SUBJECT: November 29, 2016 - Consent Item
Environmental Protection Commission Recommendation for a
Waiver Request to Terminal Platform Size and a Variance
Request to Side Setback for Boat Dock Permit BD-16-07-072 for
applicants Darryl and Abigail Hoffman.

PROJECT NAME: Darryl and Abigail Hoffman Dock
PERMIT APPLICATION NUMBER: BD-16-07-072
LOCATION/ADDRESS: 21 Killarney Drive

SUBJECT: Darryl and Abigail Hoffman Boat Dock Waiver and Variance Requests

HOFFMAN SITE PLAN
21 KILLARNEY DR
WINTER PARK

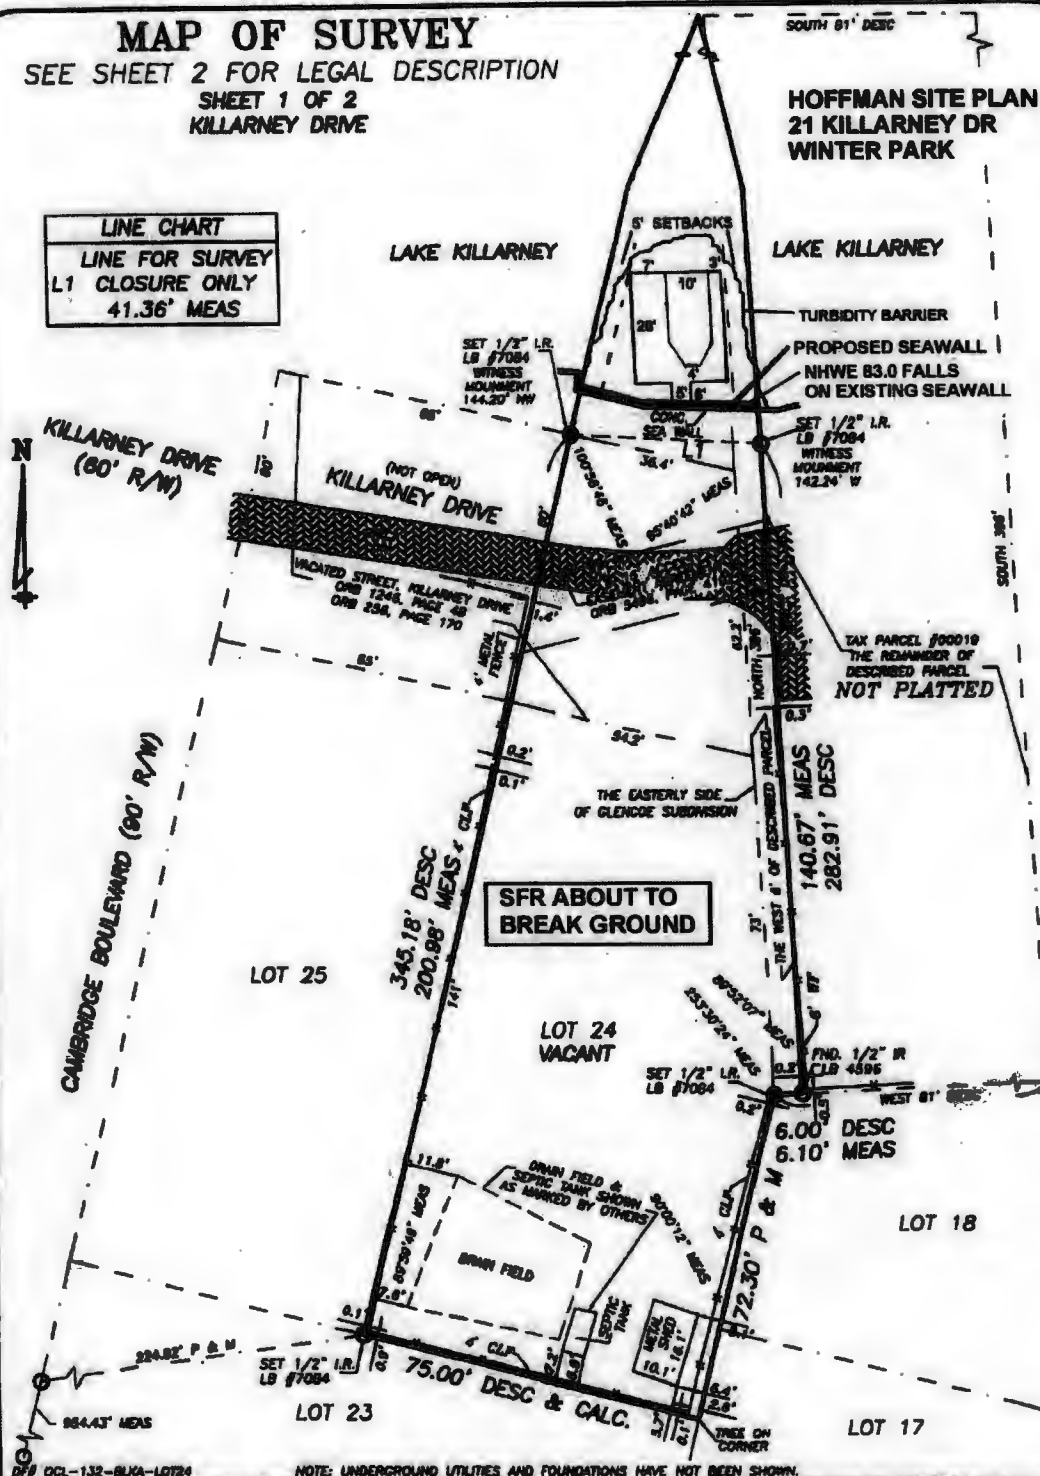
The applicants have approximately thirty-seven (37) feet of shoreline; therefore, the allowed terminal platform size for the subject lot is 370 square feet. The applicants are requesting a terminal platform size of 560 square feet.

Section 15-343(a) states, "on lots or parcels having a shoreline frontage of less than seventy-five (75) feet, docks shall have a minimum side setback of ten (10) feet from the projected property line." The subject property has thirty-seven (37) linear feet of shoreline so the required setback from the projected property lines is ten (10) feet. The applicants are requesting a setback distance of five (5) feet to each adjacent projected property line.

The lot does have a limited "pie" shape of the riparian rights, however the owner was aware of this, and the associated restrictions when the lot was purchased. The proposed terminal platform size is more than necessary for adequate ingress or egress to a boat, and the terminal mooring depth is greater than the allowed five feet (I am aware there may be an exception due to drop off of the lake depth, however the proposed dock is still 28' out into the lake).

I am also opposed to the encroachment of the 10' setback and the location of the proposed dock on the property as it negatively impairs my view of the southwest corner of the lake. From my front porch, looking left less than 30 degrees would no longer be a lake view, but rather a boat dock. Also, the proposed location of the dock on the property is situated such that from the owner's proposed house, the majority of the dock would be tucked behind two large cypress trees so as not to impair the owners' view of the lake from the proposed home to be built.

The recommendation of the Environmental Protection Officer (EPO) is to deny the request for waiver and variance based on the failure of the applicant to demonstrate that the waiver and variance requests will not have a negative impact on the adjacent property.
